Access Compliance Report

Public Rights-of-Way

(Curb Ramps)

Intersection ID: 10034929	Main Street: PROVIDENCE_GLEN_RD	Cross Street: N/A	Location: S
ADA ID: 8B2630CB3F86	Ramp Type: Perp	Initial Pass/Fail: Fail	Overall Compliance: No
Severity Score: 1.25			
Codes/Mitigation Info/Possible Solution		Field Measurements/Component Compliance

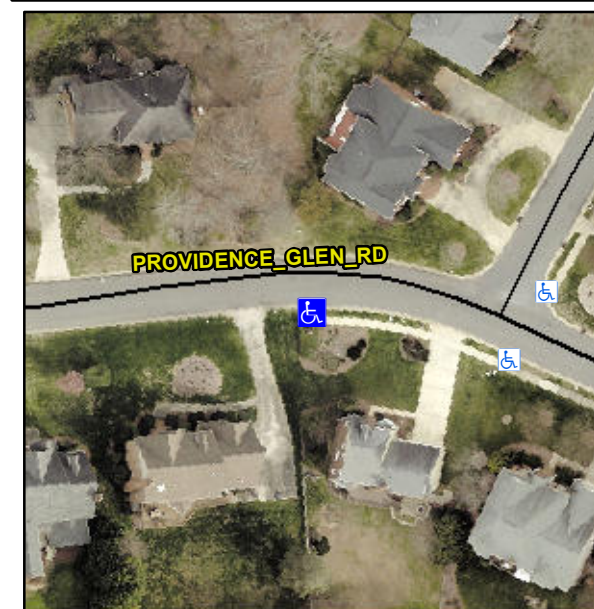
Compliance	Description	Data	Compliance	Description	Data
N/A	Ramp Length (in)	43.0	Yes	Ramp Slope (%)	7.9
Yes	Ramp Width (in)	48.0	Yes	Ramp XSlope (%)	3.7
N/A	Flare Type LT	N/A	N/A	Flare Type RT	N/A
N/A	Flare Slope LT (%)	N/A	N/A	Flare Slope RT (%)	N/A
N/A	Flare Traversable LT?	N/A	N/A	Flare Traversable RT?	N/A
N/A	Landing Length (in)	N/A	N/A	DWS Provided?	N/A
N/A	Landing Width (in)	N/A	N/A	DWS Contrast?	N/A
N/A	Landing Slope (%)	N/A	N/A	DWS Length (in)	N/A
N/A	Landing X Slope (%)	N/A	N/A	DWS Full Width?	N/A
N/A	Landing Curb? (Y/N)	N/A	N/A	DWS Offset (in)	N/A
N/A	Shared Landing?	N/A			
N/A	Gutter Ponding?	N/A	N/A	Gutter Slope (%)	N/A
N/A	Gutter Lip Ht (in)	N/A	N/A	Gutter X Slope (%)	N/A
N/A	Painted X Walk1?	No	N/A	Painted X Walk2?	N/A
	X Walk 1 Direction	To N		X Walk 2 Direction	N/A
N/A	X Walk 1 Width (in)	N/A	N/A	X Walk 2 Width (in)	N/A
	X Walk 1 Slope (%)	4.0		X Walk 2 Slope (%)	N/A
	X Walk 1 X Slope (%)	6.7		X Walk 2 X Slope (%)	N/A

N/A	Ramp inside XWalk1?	N/A	N/A	Ramp inside XWalk2?	N/A
	Road Slope (%)	6.7	N/A	Clear Space?	N/A
	Road X Slope (%)	4.0	N/A	Clear Space to XWalk (in)	N/A
N/A	Any Obstructions?	N/A	N/A	Storm Grate/Utility Hazard?	N/A
	Obstruction Type			Storm Grate/Utility Type	
		N/A			N/A
			Yes	Surface Condition? (G/P)	Good

Remove & Replace Entire Ramp.
